**Vieux Carré Architecture
Committee Meeting**

Tuesday, November 24, 2020

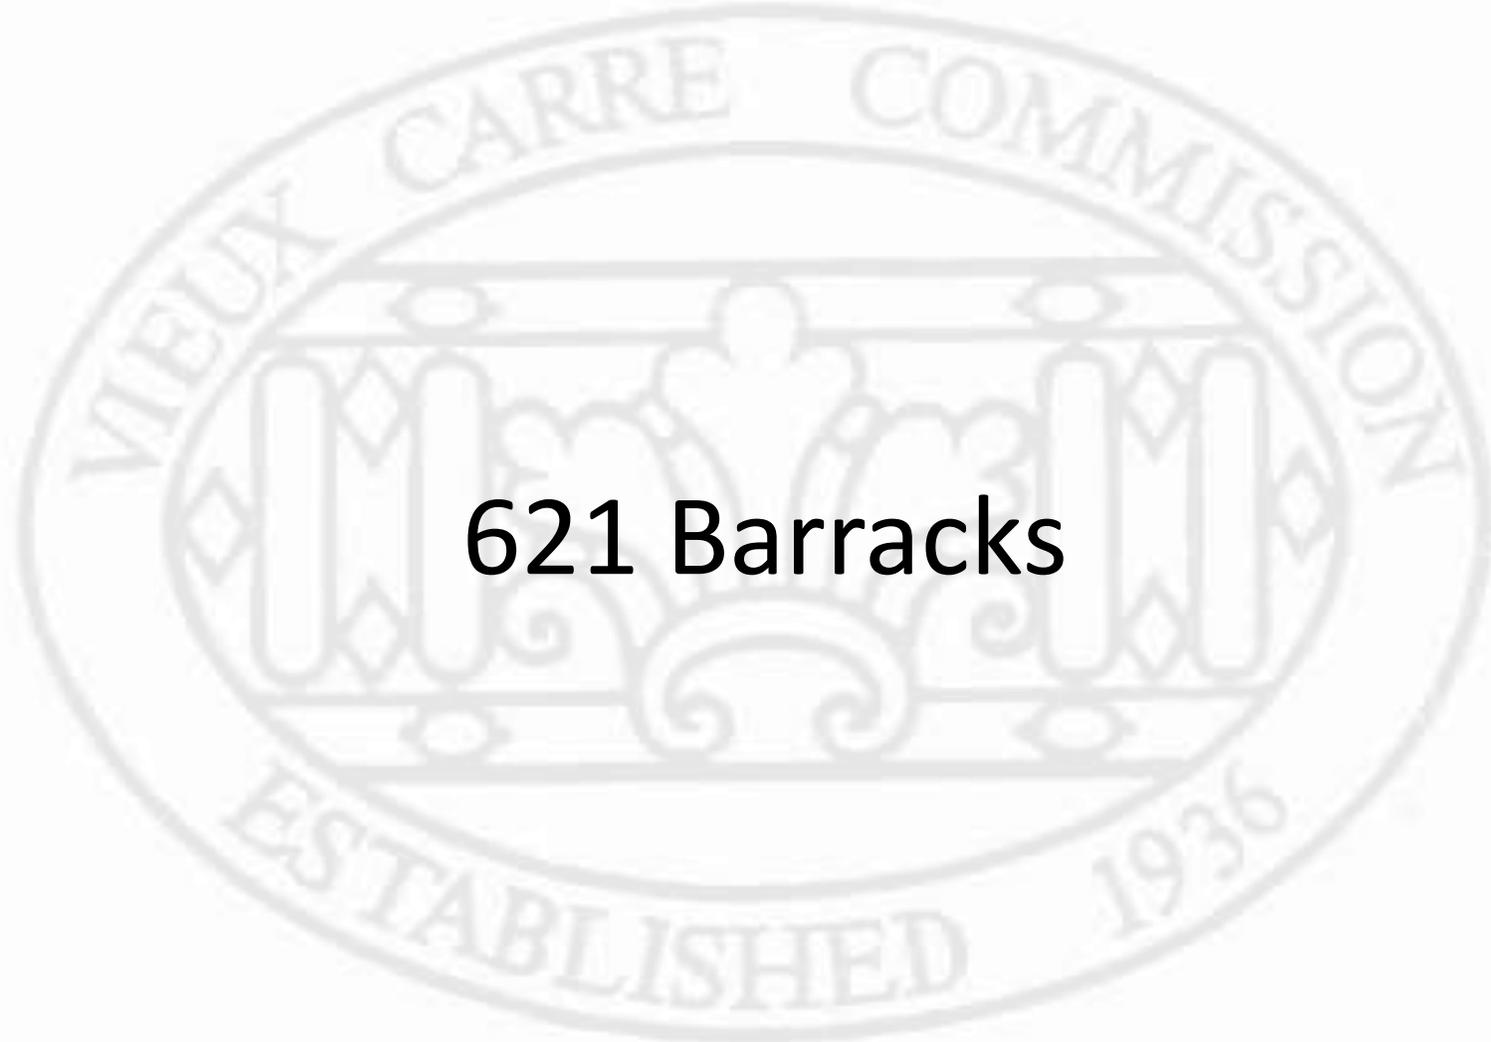
The applicant proposes to replace a total of fifteen (15) existing decorative light fixtures with a variety of new Bevolo light fixtures. This includes replacing eleven (11) existing hanging fixtures with new hanging fixtures ranging in size from 24" above the carriageway to as small as 14" for fixtures located at rear balconies. The proposal also included replacing three (3) existing wall mounted fixtures with new 18" and 15" flush mounted fixtures. Some existing fixtures will be eliminated as part of the overall project.

The Guidelines recommend limiting the number of decorative fixtures to avoid a cluttered appearance and locating the fixtures near a focal point of the building, such as the primary entrance door. (VCC DG: 11-7) If this were a brand new installation, staff would recommend an overall reduction in the number of fixtures, however, as this is replacement of existing fixtures and staff found photographs showing these fixtures in place as early as 1991, staff finds their replacement potentially approvable provided that the new fixtures are compatible in size to the fixtures they are replacing and the installation locations. Some of the new fixtures will be larger than the existing but staff notes that some existing fixtures will be eliminated, it appears particularly at the rear balconies.

Mr. Albrecht read the staff report with Mr. Arceneaux present on behalf of the application. Mr. Fifield asked if cut sheets had been submitted. Mr. Albrecht stated no. Mr. Arceneaux stated that they wanted to change out the lights to beautify the area and reduce the number of total lights. Ms. DiMaggio stated that she needed pictures. Mr. Bergeron asked if staff usually handled this. Ms. Bourgogne asked if they were gas or electric. Mr. Albrecht stated electric. Mr. Fifield stated that the Committee needed better documentation. He went on to say that slide 128 showed 2 wall sconces. He asked the applicant if these were to be retained or removed. Mr. Arceneaux stated that they would be replaced with the Williamsburg sconce. Mr. Fifield stated that this was exactly why they needed better documentation. Mr. Arceneaux stated that they would be replacing all fixtures outside, in the carriageway and under the walkways. Mr. Fifield stated that this might be ok, but that currently with what was presented it was hard to picture. Mr. Bergeron stated that he needed to see a plan, that even a hand sketch would help him know what went where. With nothing left to discuss, the Committee moved on to the next item.

Staff recommends approval of the application with any final details to be worked out at the staff level.

Discussion and Motion: Ms. DiMaggio made the motion for a deferral in order for the applicant to have time to submit the necessary materials requested at today's meeting. Mr. Bergeron seconded the motion and the motion passed unanimously.
